## Huawei Technologies Co., Ltd.

## **Difference Declaration Letter for FCC**

## Article 1: Difference description:

The difference between model ELE-L04m and model ELE -L29m is show in the below table:

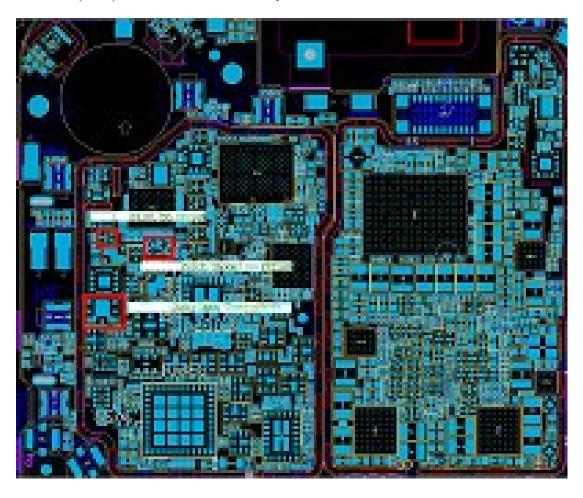
The ELE-L29m/ELE-L09m and ELE-L04m is family models, the model ELE-L29m and ELE-L09m are identical except for ELE-L09m support single SIM card which deleted by software. Based on above details of model difference, some original data of FCC IC:QISELE-L04M remains representative of FCC IC:QISELE-LX9M after engineering judgment, detailed explanation of re-uesd data as below:

For SAR, new full test of UMTS Band IV, LTE B2/B4/B7. For the other frequency bands, QISELE-LX9M shares the same test data of QISELE-L04M and is tested at the SAR worst case of QISELE-L04M the re-used test data in QISELE-LX9M refer to QISELE-L04M Report NO.SYBH(Z-SAR)20190401017001-2. For QISELE-LX9M, we only test ELE-L29m, ELE-L09m is not tested. The metal of the ELE-L29m card slot is the same as that of the
